Product Change Notice (PCN)

PCN Number: PCN-0451156R-01

Product(s) Affected: PJ-039A, PJ-039B, PJ-039AH, PJ-039BH

Current version	New version
Outlook		
Front	 <p>without chamfer</p>	 <p>with chamfer</p>

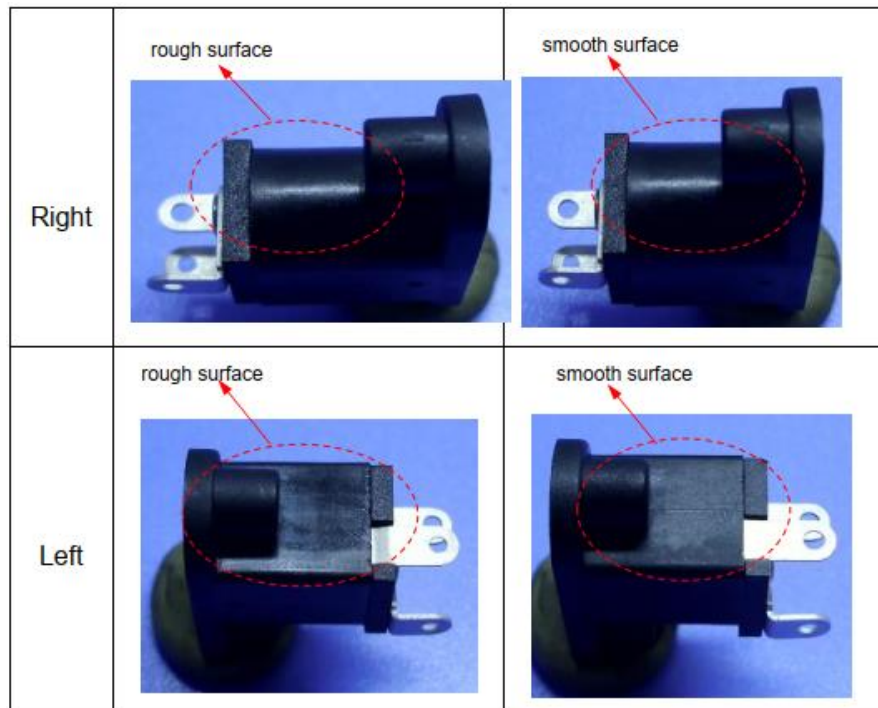
Description of Change: Thickness of pin 2 changed from 0.2mm to 0.25mm. Aesthetic changes as shown in below comparisons:

Back	<p>cave marking location</p>  <p>smaller</p> <p>cave marking location</p>	<p>cave marking location</p>  <p>thicker</p> <p>cave marking location</p>
Top	<p>with injection mark</p>  <p>thickness of pin#2 is 0.2mm</p>	<p>without injection mark</p>  <p>thickness of pin#2 is 0.25mm</p>
Bottom	<p>without injection mark</p> 	<p>with injection mark</p>
